ADDENDUM No. 7 – February 22, 2022

<p>ARCHITECT:</p>  <p>LAMOUREUX PAGANO ASSOCIATES ARCHITECTS lpa.com</p>	<p>PROJECT TITLE:</p> <p>Doherty Memorial High School</p> <p>299 Highland Street, Worcester, MA 01602</p>	<p>REFERENCE: 4/A8.20</p> <p>DRAWING TITLE:</p> <p>Bollard Detail</p>	<p>DATE: 02/16/22</p> <p>DRAWING NUMBER:</p> <p>ADD-5 A-095</p>
--	---	---	---

1. DRAWING ADD-5 A-095 BOLLARD DETAIL (ADDENDUM #5)

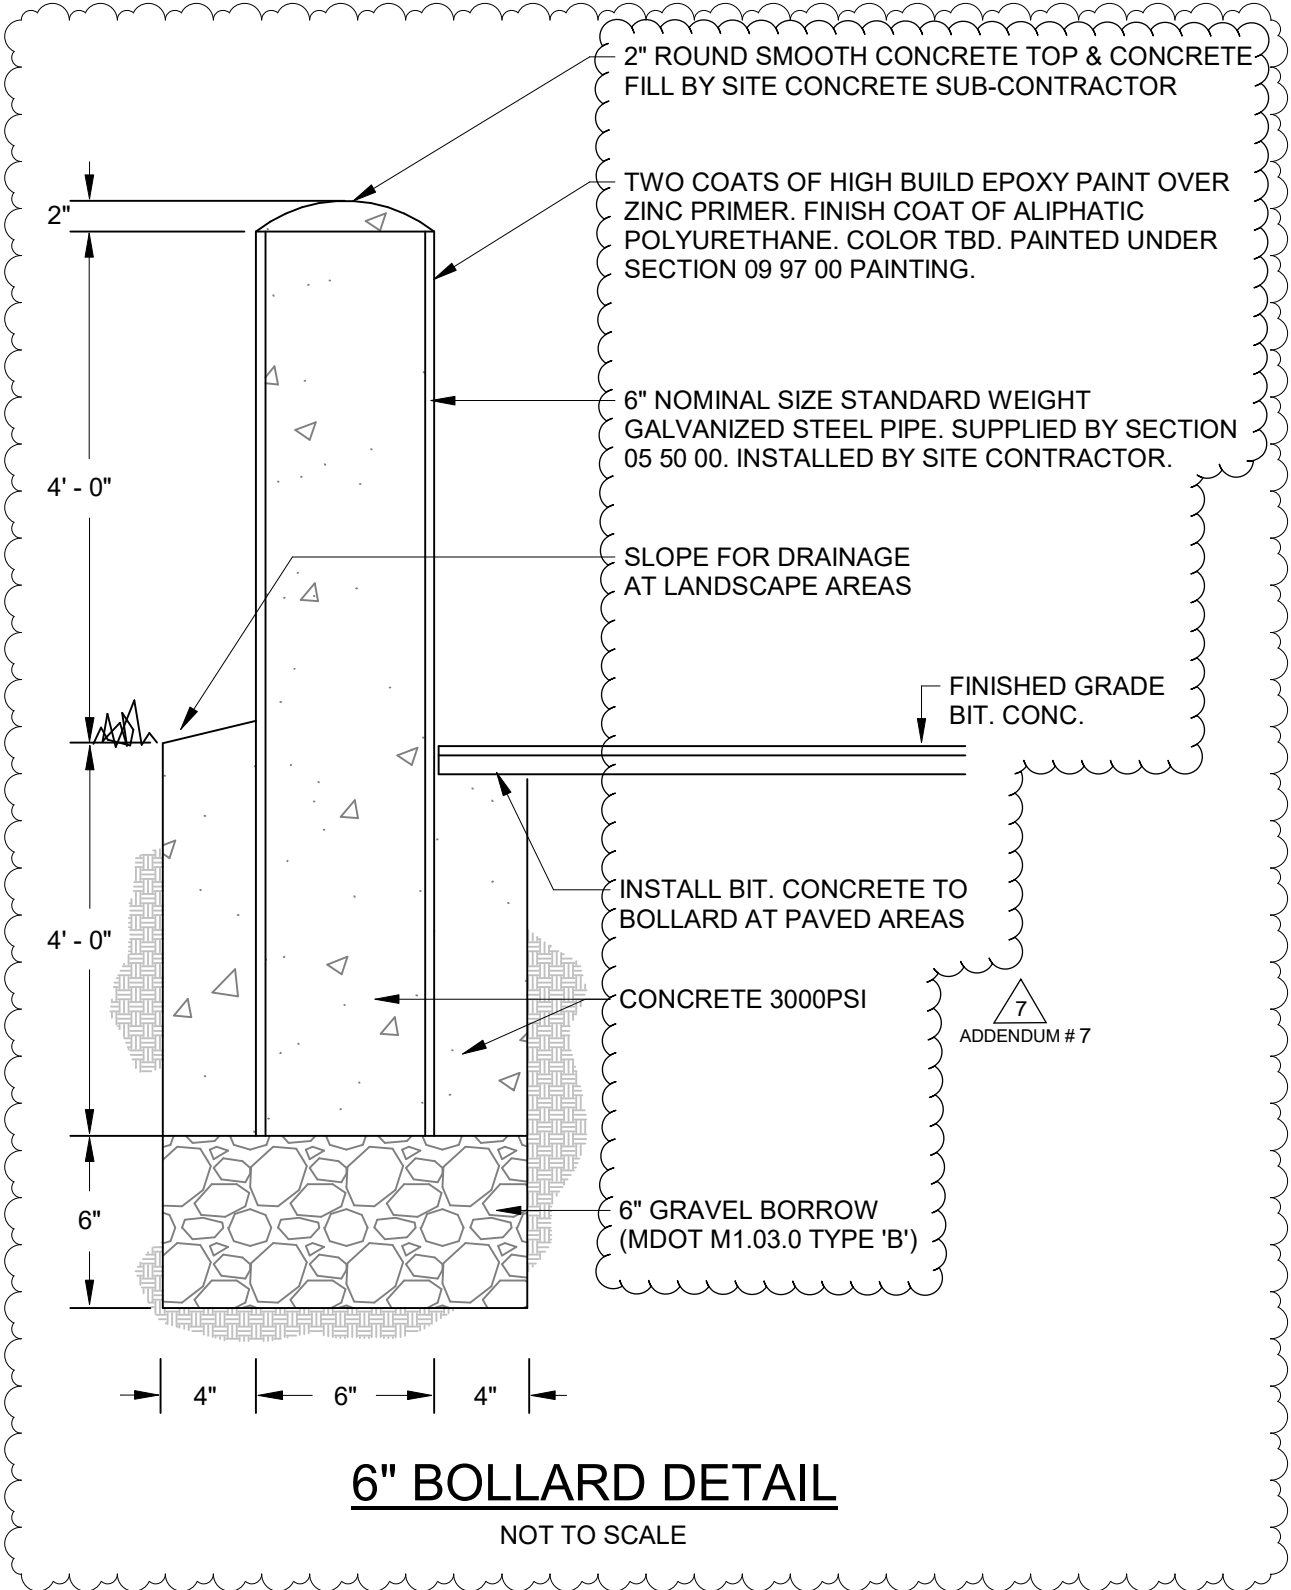
A. Corrupted text has been corrected. Refer to sketch ADD-5 A-095 attached to this addendum.
